Addendum #2
Bid Opportunity: 24-7540-RFT - Pioneer Park
Public School Interior Renovations
Revised Closing Date: Tuesday, April 16, 2024 2:00 PM

Project Name:	WRDSB Pioneer Park PS Renovations	Date Issued:	April 10, 2024
Quasar Project #:	CM-19-083		
Distribution			
Ward99	Tina Ranieri-D'Ovidio		tr@ward99architects.com
Quasar	Michael Hughes		Michael.hughes@quasarcg.com
Addendum #:	M2		
Revision #:	0

Project Name:	WRDSB Pioneer Park PS Renovations	Date Issued:	April 9, 2024
Quasar Project #:	ED-20-312

VOLLEYBALL LINES - BASED ON
CENTER OF SOCKETS

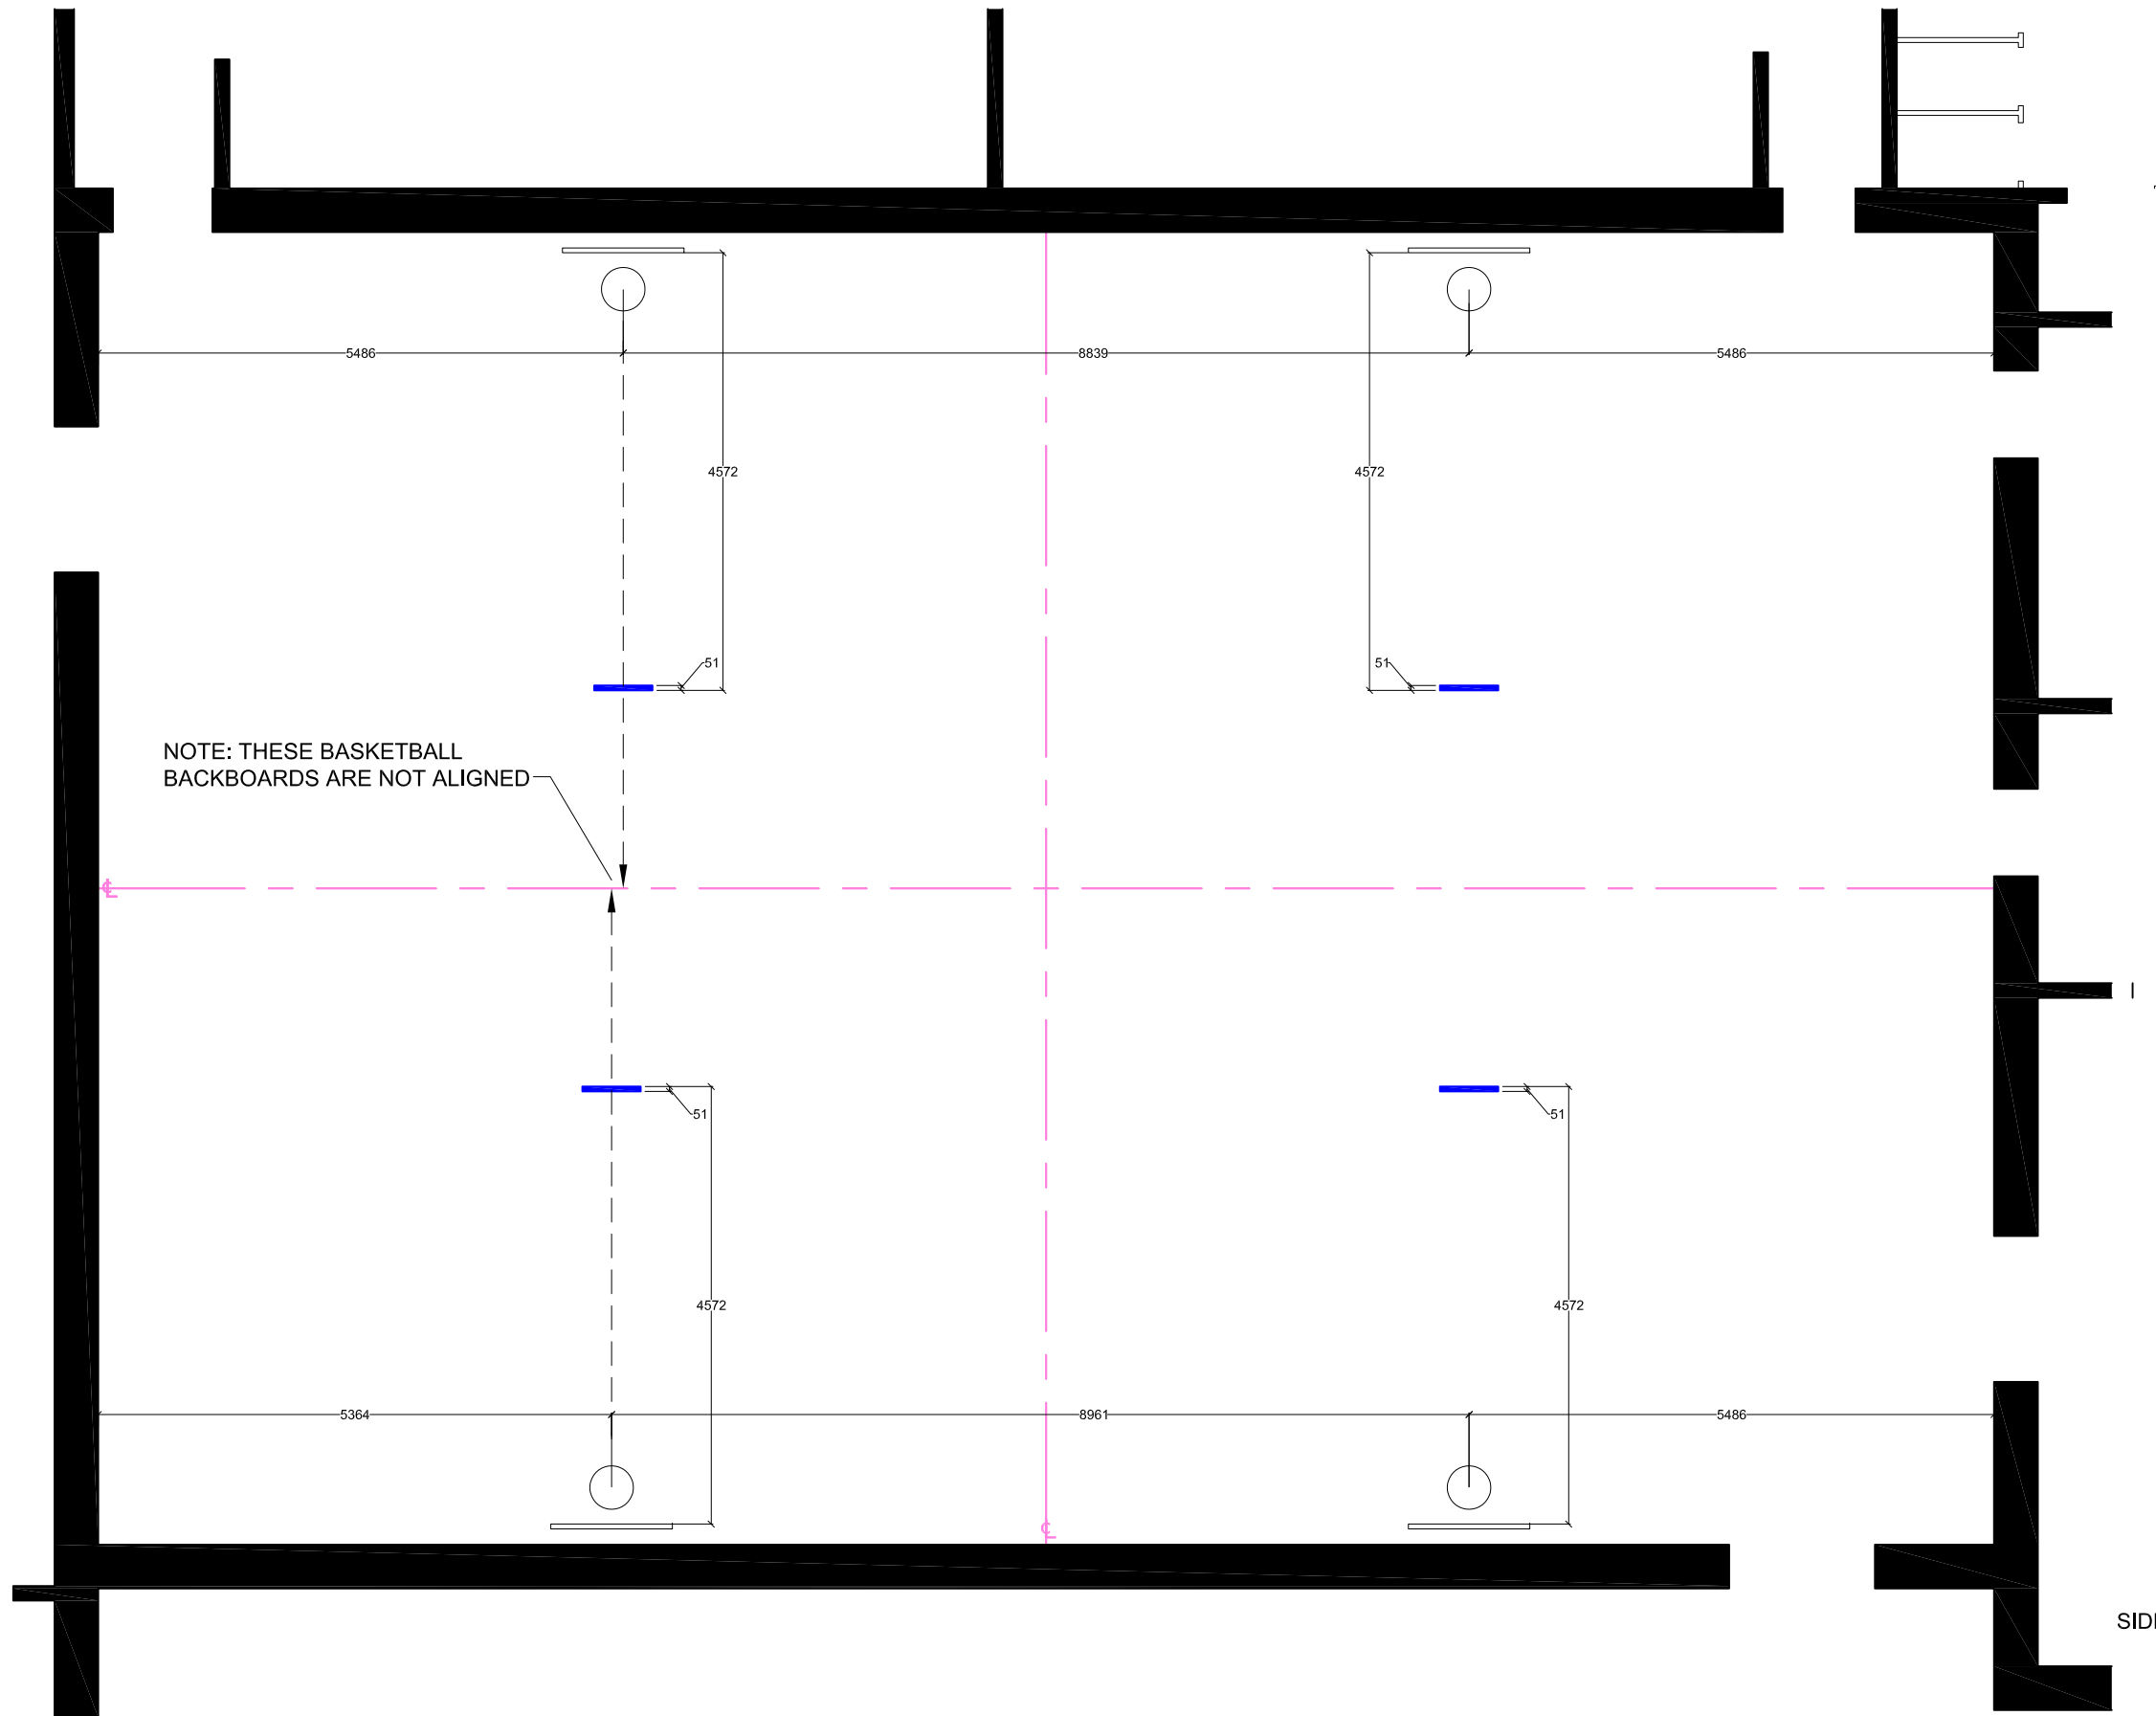
Refer to previously issued Addendum No.1. For further clarification of all game lines required to be included in the Gymnasium, find attached separate layouts of each game line required with associated dimensions.

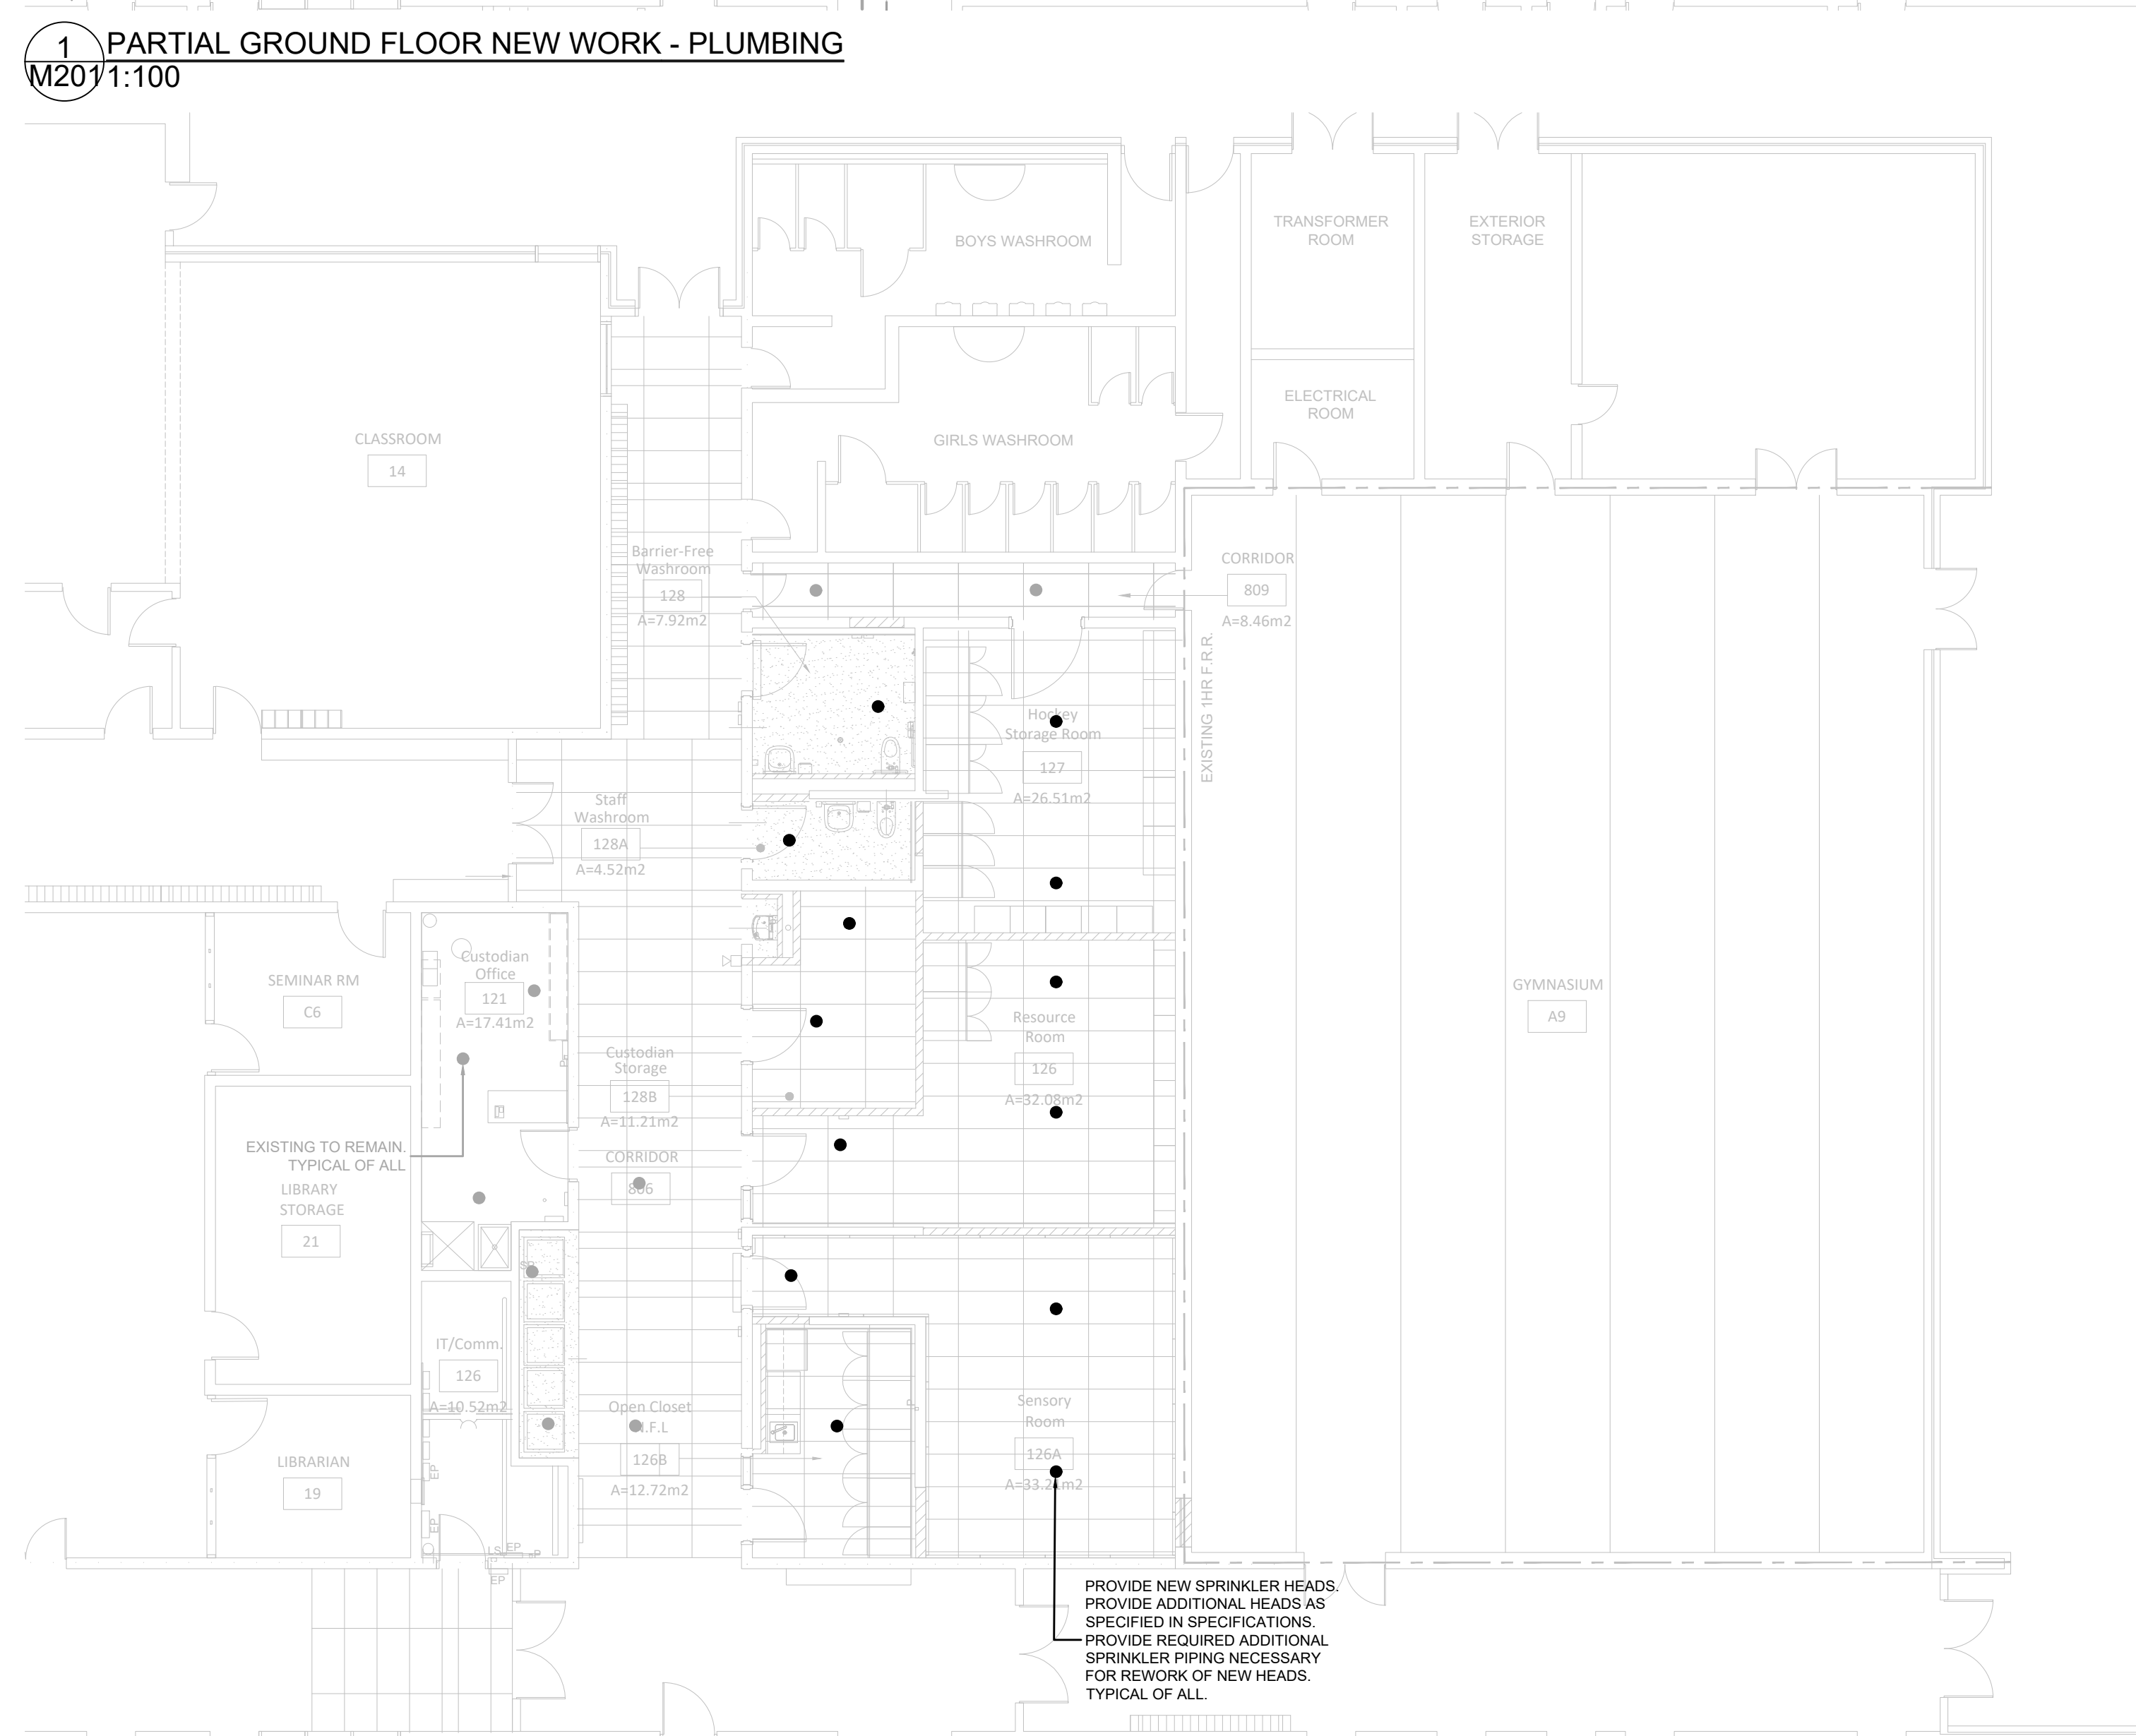
1. **M101 – PARTIAL GROUND FLOOR DEMOLITION PLAN**
 Refer to attached drawing and include for all work shown including the below revisions:
 - a. Added note for existing bottle filling station to be removed and reinstalled.
2. **M201 – PARTIAL GROUND FLOOR NEW WORK**
 Refer to attached drawing and include for all work shown including the below revisions:
 - a. Added note for existing bottle filling station to be reinstalled.
